# Roar Fashion Ltd.

Ward # 09, Kathali, Bhaluka, Mymensingh.

01 March 2020

2<sup>nd</sup> floor layout plan

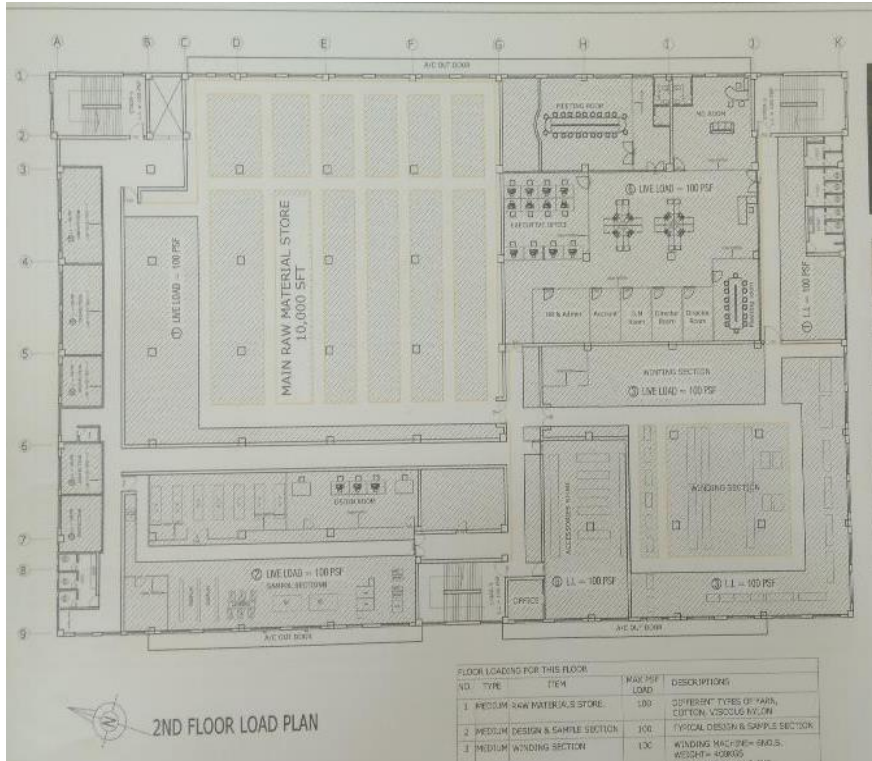
Signification vibration was observed at winding section on 2<sup>nd</sup> floor which may cause the long-term fatigue effect. Building engineer is required to investigate the long-term effect of the vibration and suggest remediation.

Corrosion in exposed rebar

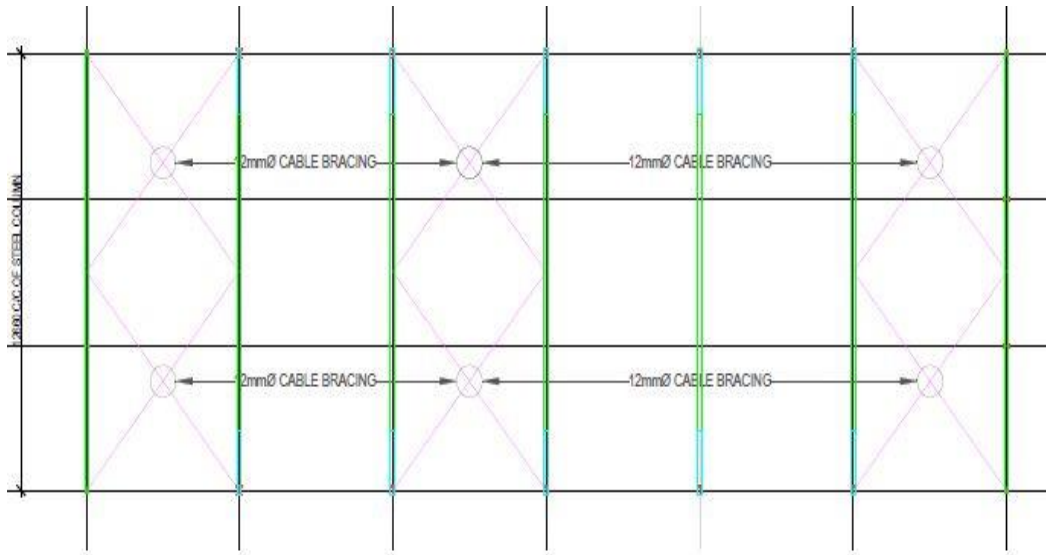
Corrosion found in exposed rebar at roof level. Building engineer is required to provide rust proof paint to prevent further corrosion.
